Access Compliance Report

Public Rights-of-Way

(Curb Ramps)

Intersection ID: 48304	Main Street: FAZENDA_DR	Cross Street: GANSO_LN	Location:	S
ADA ID: 9452DB05DEC9	Ramp Type: PerpDiag	Initial Pass/Fail: Fail	Overall Compliance: No	Severity Score: 37.5
Codes/Mitigation Info/Possible Solution		Field Measurements/Component Compliance

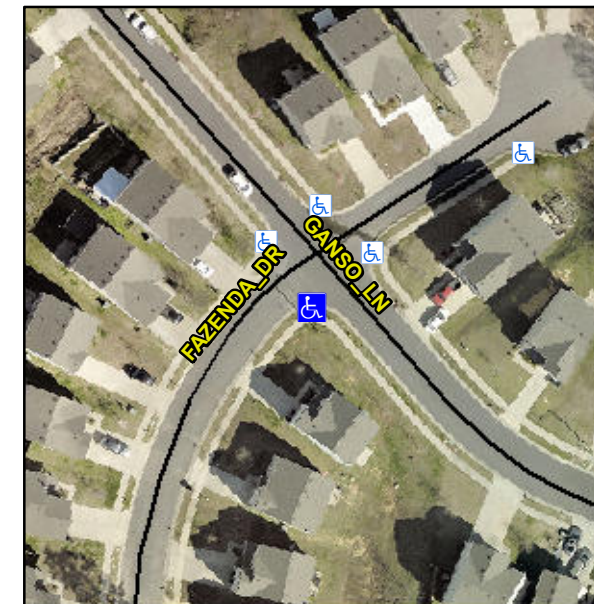
Not Found, R304.2.2, R304.5.3

Compliance	Description	Data	Compliance	Description	Data
N/A	Ramp Length (in)	48.5	No	Ramp Slope (%)	8.5
Yes	Ramp Width (in)	48.0	No	Ramp XSlope (%)	12.0
N/A	Flare Type LT	N/A	N/A	Flare Type RT	N/A
N/A	Flare Slope LT (%)	N/A	N/A	Flare Slope RT (%)	N/A
N/A	Flare Traversable LT?	N/A	N/A	Flare Traversable RT?	N/A
N/A	Landing Length (in)	N/A	N/A	DWS Provided?	N/A
N/A	Landing Width (in)	N/A	N/A	DWS Contrast?	N/A
N/A	Landing Slope (%)	N/A	N/A	DWS Length (in)	N/A
N/A	Landing X Slope (%)	N/A	N/A	DWS Full Width?	N/A
N/A	Landing Curb? (Y/N)	N/A	N/A	DWS Offset (in)	N/A
N/A	Shared Landing?	N/A			
N/A	Gutter Ponding?	N/A	N/A	Gutter Slope (%)	N/A
N/A	Gutter Lip Ht (in)	0.5	N/A	Gutter X Slope (%)	N/A
N/A	Painted X Walk1?	No	N/A	Painted X Walk2?	No
	X Walk 1 Direction	To NE		X Walk 2 Direction	To NW
N/A	X Walk 1 Width (in)	N/A	N/A	X Walk 2 Width (in)	N/A
	X Walk 1 Slope (%)	7.5		X Walk 2 Slope (%)	2.3
	X Walk 1 X Slope (%)	6.7		X Walk 2 X Slope (%)	10.9

N/A	Ramp inside XWalk1?	N/A	N/A	Ramp inside XWalk2?	N/A
	Road Slope (%)	11.4	N/A	Clear Space?	N/A
	Road X Slope (%)	3.4	N/A	Clear Space to XWalk (in)	N/A
N/A	Any Obstructions?	N/A	N/A	Storm Grate/Utility Hazard?	N/A
	Obstruction Type			Storm Grate/Utility Type	
		N/A			N/A
		Yes		Surface Condition? (G/P)	Good

Remove & Replace Curb Ramp With Two New Directional Ramps or Equivalent.
